ACCESSION NBR: 9710200063 DOC. DATE: 97/10/14 NOTARIZED: NO DOCKET #
 FACIL: 50-275 Diablo Canyon Nuclear Power Plant, Unit 1, Pacific Ga 05000275
 50-323 Diablo Canyon Nuclear Power Plant, Unit 2, Pacific Ga 05000323
 AUTH. NAME AUTHOR AFFILIATION
 RUEGER, G.M. Pacific Gas & Electric Co.
 RECIP. NAME RECIPIENT AFFILIATION
 Document Control Branch (Document Control Desk)

SUBJECT: Forwards response to request for addl info on LAR 97-11 re auxiliary saltwater sys piping bypass unreviewed safety question. W/one oversize drawing.

PG&E Letter DCL-97-177

Response to NRC Request for Additional Information on License Amendment
Request 97-11, Auxiliary Saltwater System Piping Bypass Unreviewed Safety
Question

Log of Boring B-1 (Sheet 1 of 1)
 Diablo Canyon ASW Bypass
 San Luis Obispo County, California

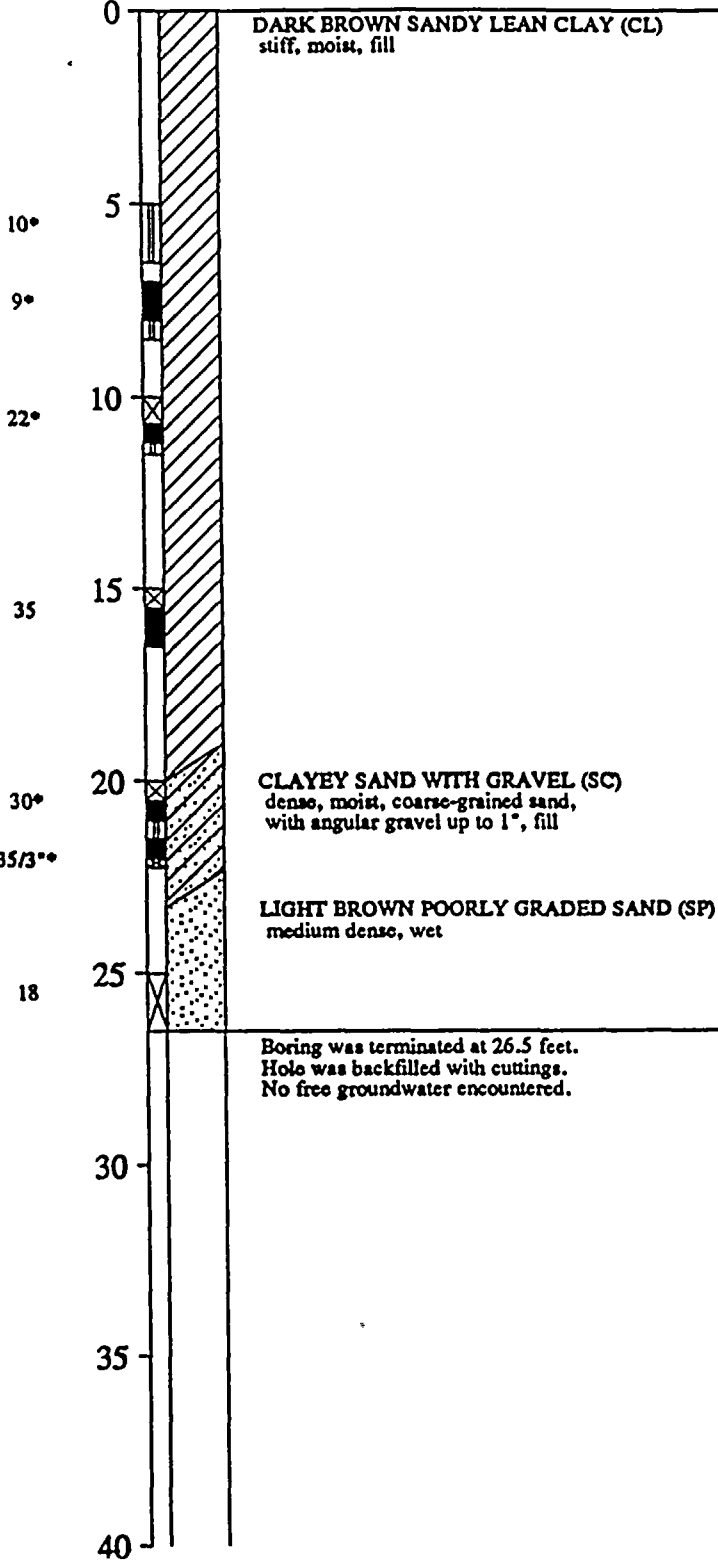
Justify your conclusion that the zone of potential liquefaction is limited in size, covering an area about 10 to 20 feet by 100 feet with a thickness of about 5 feet by providing both longitudinal sections and transverse (cross) sections of the soil profiles in the affected area of the ASW system bypass piping and indicating all pertinent soil parameters, such as the standard penetration test (SPT) blow counts, the fines content, etc., of the different soil layers, the elevations of the ASW pipe lines and bedrock. Also provide a legible and reasonably large size drawing showing the location of the AW system bypass piping and the soil borings.

The May 8, 1996, HLA report identified the presence of medium dense sand, of limited vertical extent near the groundwater table (GWT), in two borings, B-1 and B-4. These borings are located within the original engineered backfill placed in 1972 and 1973 following construction of the CWCs and original ASW pipes. Soil classifications and abbreviations referenced are defined in ASTM D2487.

- Test boring B-1 shows a standard penetration test (SPT) blow-count of 18 at a depth of 25 feet in wet, medium dense, poorly graded sand (SP). This location is shown at elevation -1 foot, Mean Sea Level (MSL), on SK-C-4016686. This sand layer extends between depths of 23 feet and 26.5 feet (elevations +1 foot to -2.5 feet). The layer is overlain by clayey sand with gravel (SC) with higher blow counts.
